EMULATOR II SCHEMATICS

Mac Interface 1.B 23 September 1985

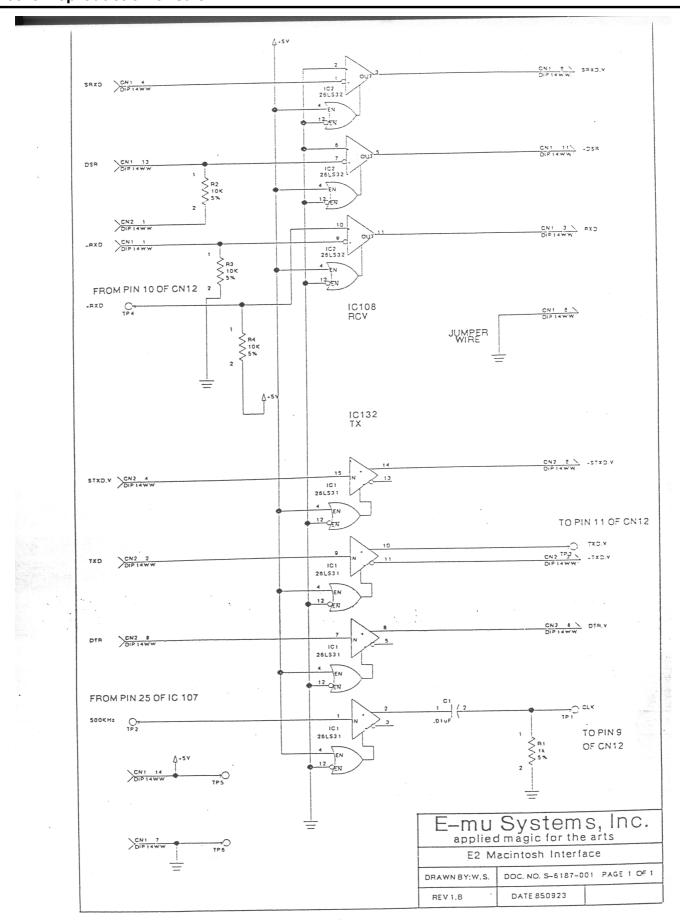
Change Detail from 1.A: R1 reduced to 1k to increase clock negative transition to 1.0V
